SI B17 02 12
Cooling Systems

This Service Information bulletin supersedes SI 17 02 12 **dated November 2012.**

Low Coolant Warning Is Displayed

F30 with the N20 or N26 engine

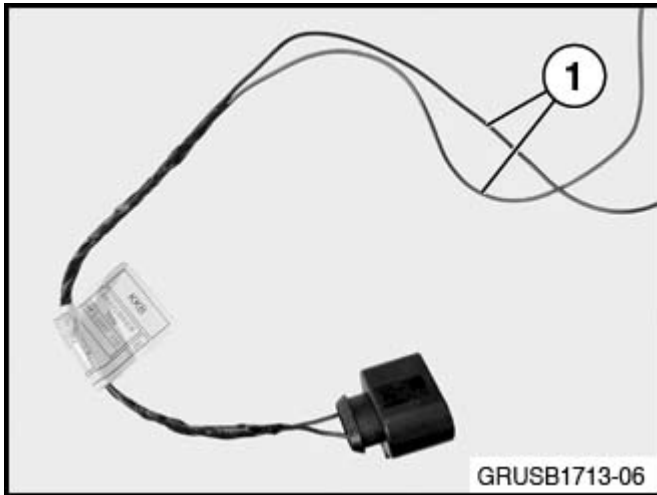
Cut the wiring on the old connector for the coolant level sensor at 5 mm from the connector (1).

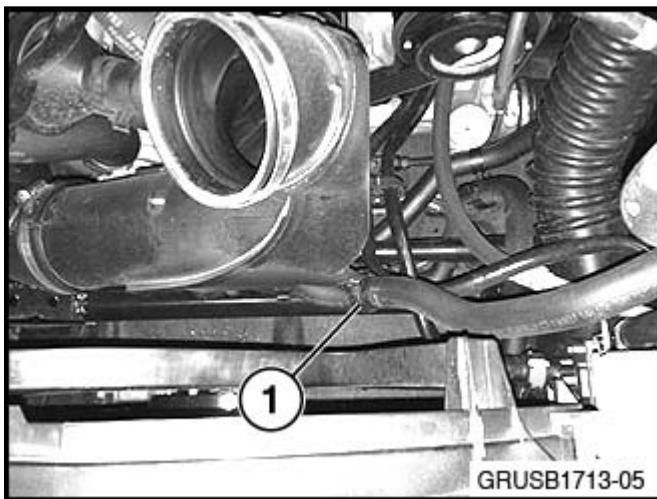
Cut the replacement harness (from connector repair kit P/N 61 11 9 289 009) at 50 mm away from the taped portion of the harness (1). Crimp the new level sensor harness to the body harness with the provided cable connectors and heat shrinking hose
